48 CUMBERLAND AVENUE

HEARING ON APPEAL UNDER THE ZONING ORDINANCE OF Rose A. Swanson

Memorandum from Department of Building Inspection, Portland, Maine

Permit to demolish existing rear platform and close up door and to construct 3'x3' platform on right side of building and to change existing window to door with glazed panel, to remove existing non-bearing wall between two rooms, and to install window approximately 24" high and 30" wide in kitchen is approved subject to any conditions of your recent appeal and the following:

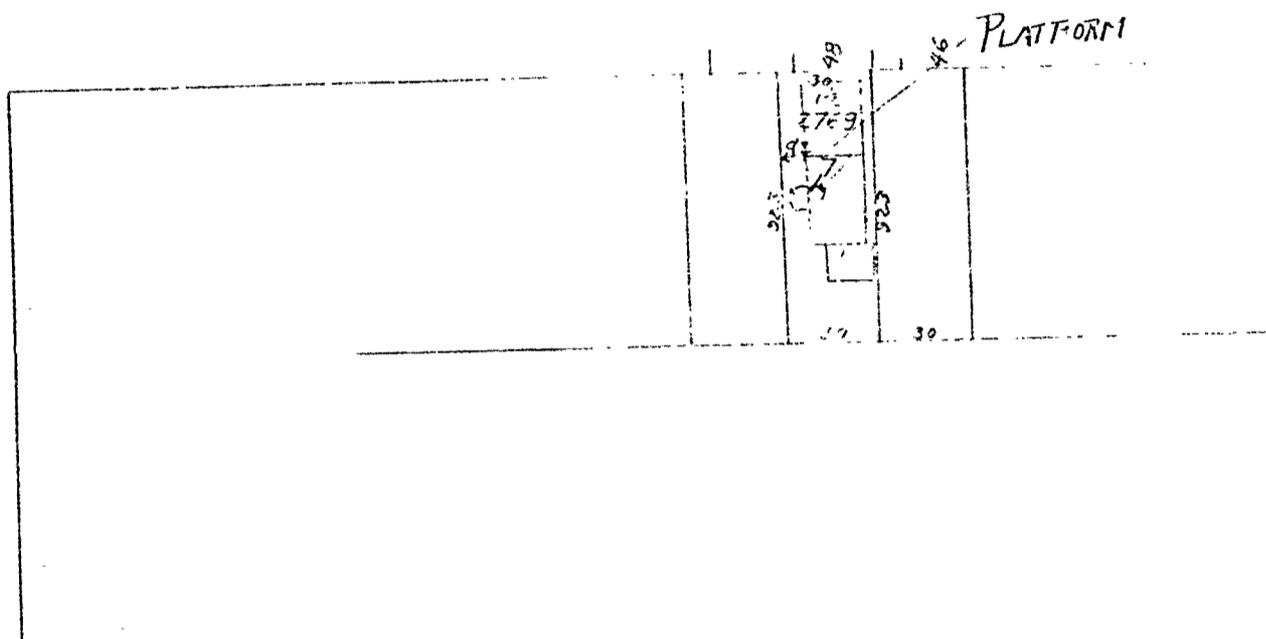
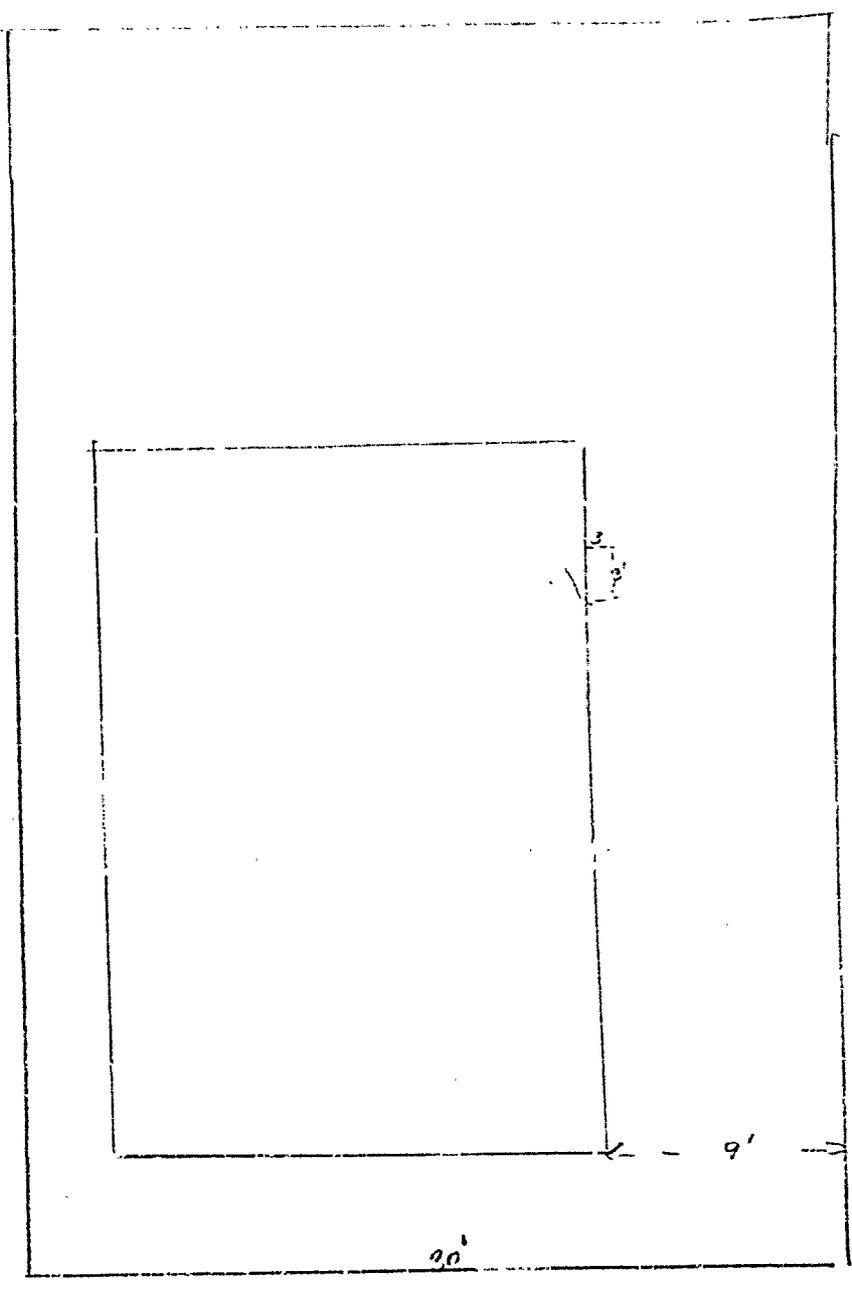
--The 2x6" platform joists are to either rest on the top of the 4x6" sill or are to be notched over 2x3" nailing strips securely spiked or bolted to the sills.
